RE: Certificate of Appropriateness Application
BAR 14-10-03
113 West Market Street
Tax Parcel 330175000
Lu Mei Chang, Owner/ Scott Gordon, Applicant
Transformation of Porch Roof to Roof Deck

**CITY OF CHARLOTTESVILLE
BOARD OF ARCHITECTURAL REVIEW
STAFF REPORT
October 21, 2014**

BAR 14-10-03
113 West Market Street
Tax Parcel 330175000
Lu Mei Chang, Owner/ Scott Gordon, Applicant
Transformation of Porch Roof to Roof Deck

1 PROPOSED FRONT (SOUTH) ELEVATION
SCALE: 1/4" = 1'-0"

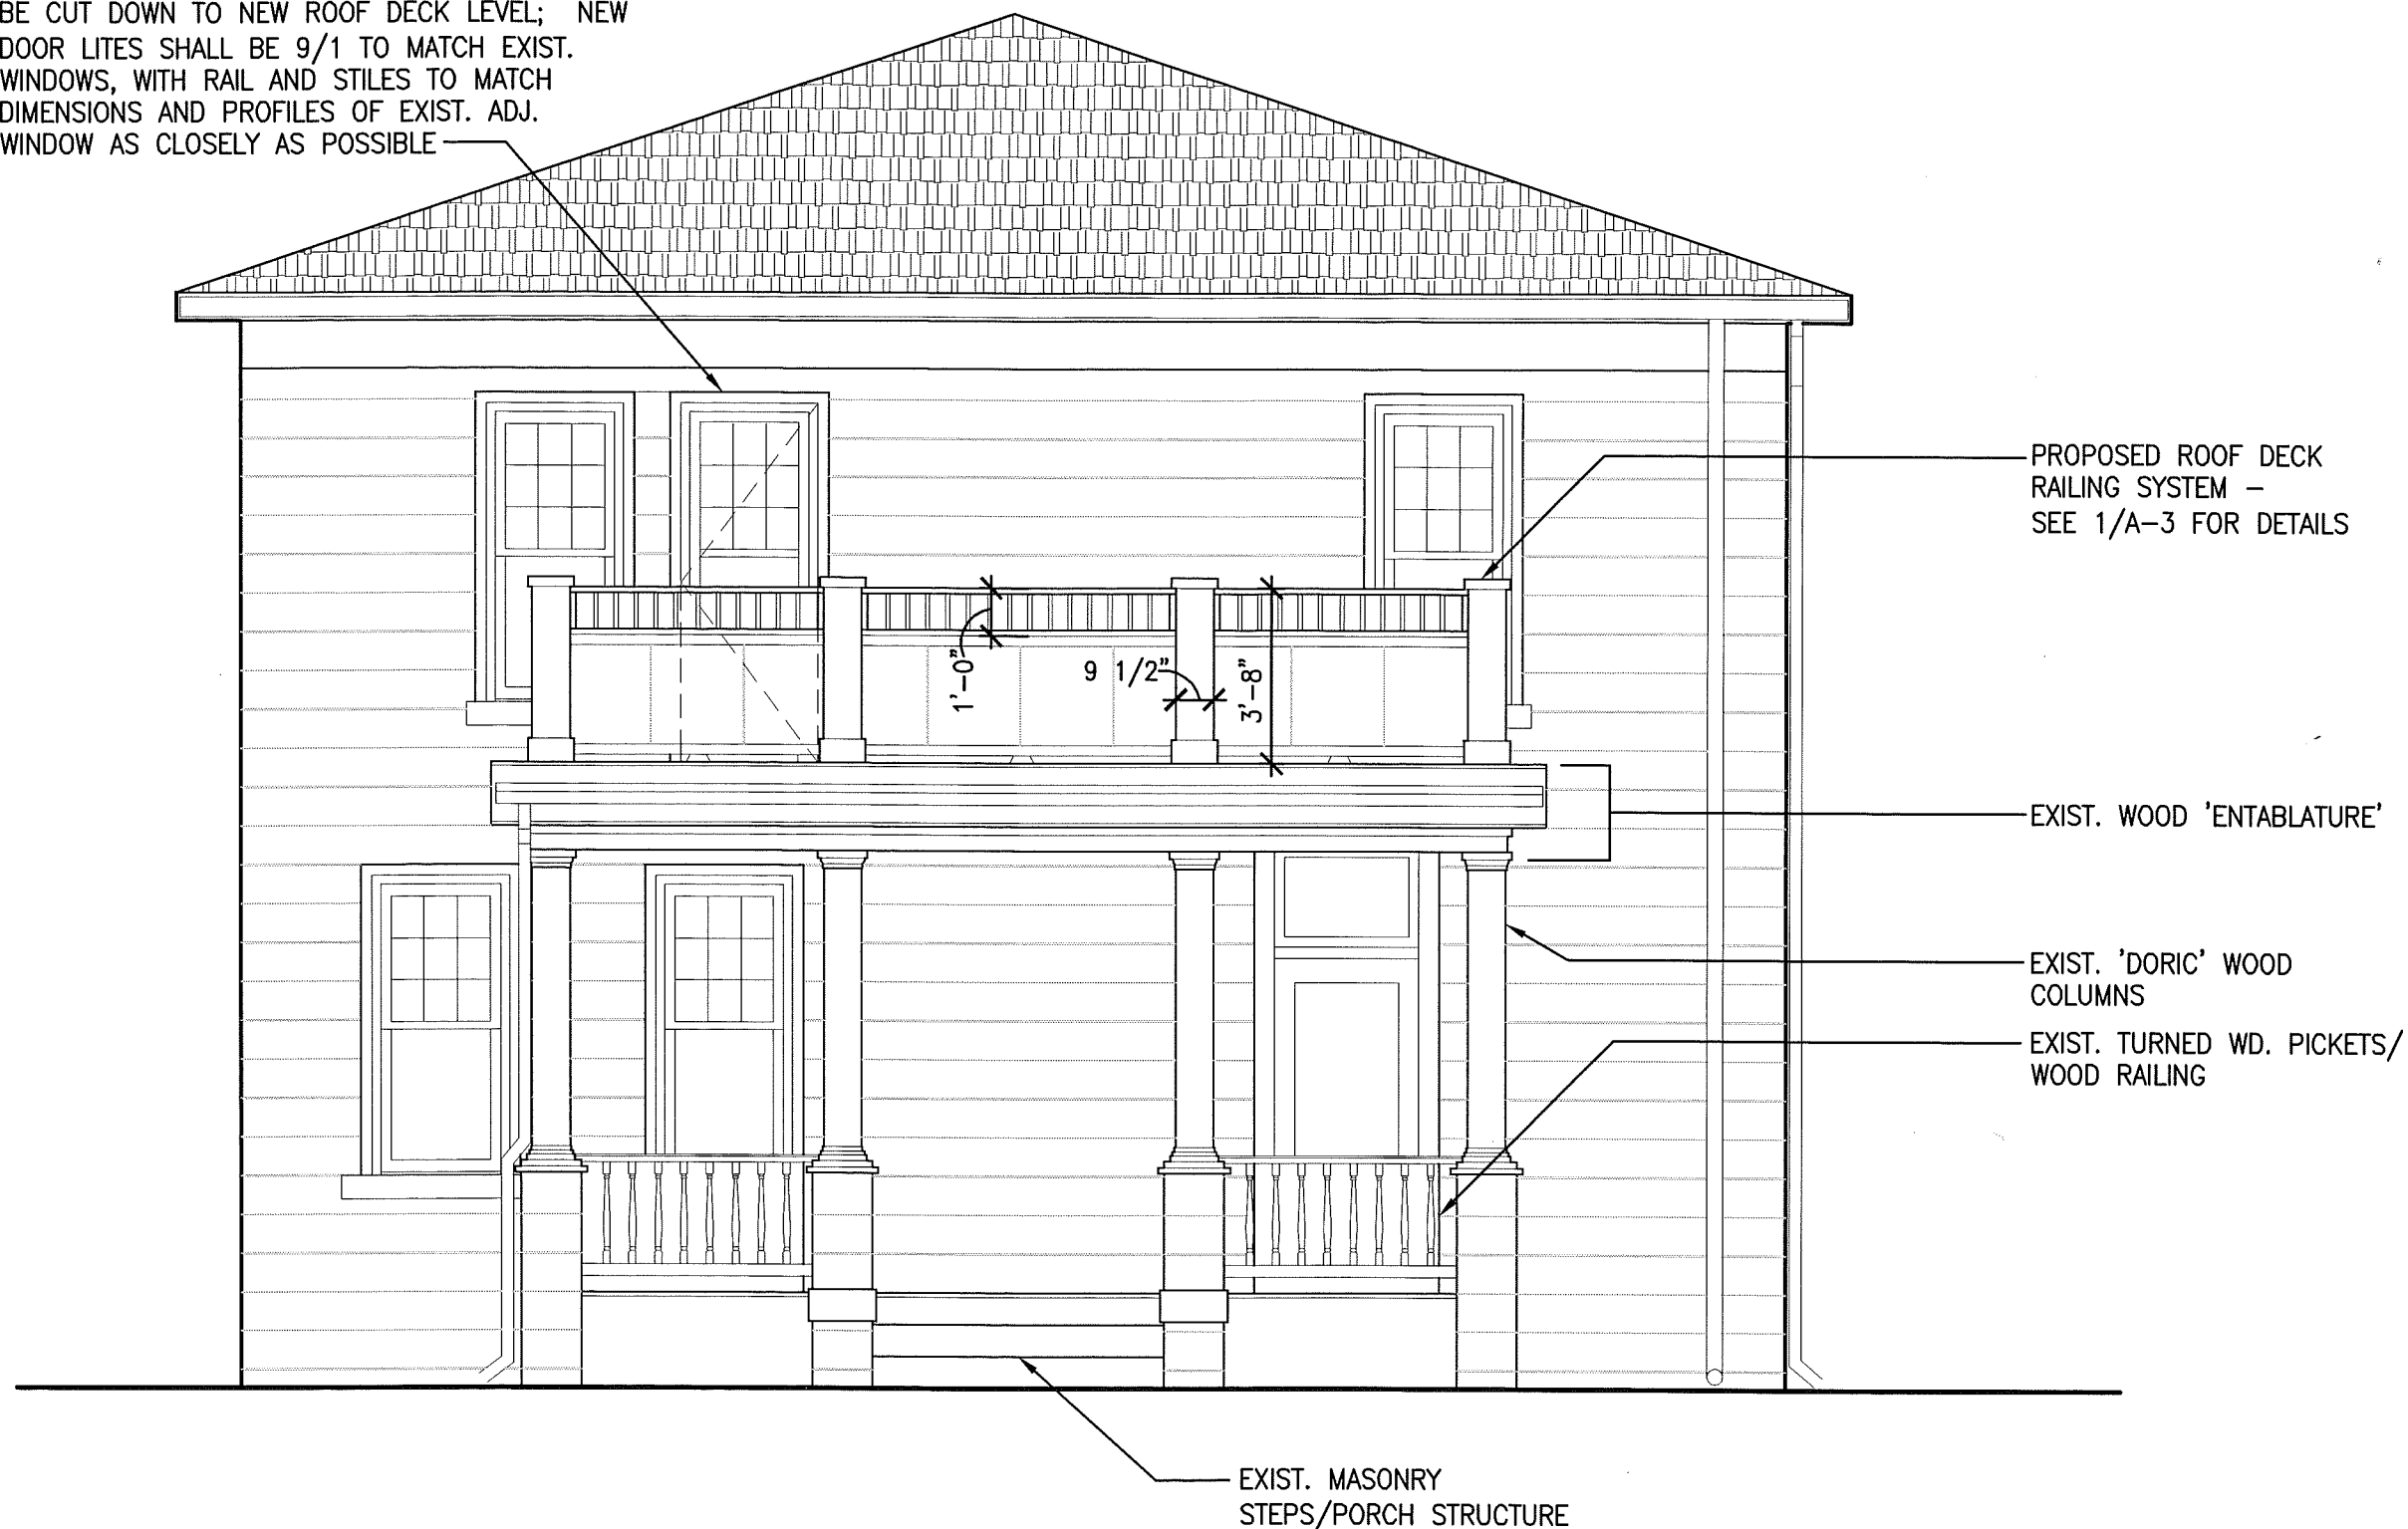
Making use of a historic building is generally desirable, and the applicant has been a successful restaurant owner in this location for years. The drawings are clear and thorough. However, the proposal presents some concerns. The BAR should take into careful consideration how drastically the change from a window to door, and introducing roof dining will impact the façade of the building.

The building directly next to this has an identical façade and any change, especially one of this magnitude, will alter that likeness. The designer has tried to minimize the impact of the new door, which, if permitted, should match the materials of the adjacent windows. However, adding a solid rail will change the massing of the façade. If permitted, the rail on the roof porch should be wood pickets to mimic the rail found at ground level. Building code may require the rail to be guardrail height, 42”.

The BAR denied (7-0) the application for the roof deck and changing the window to a door, because it does not meet guidelines.
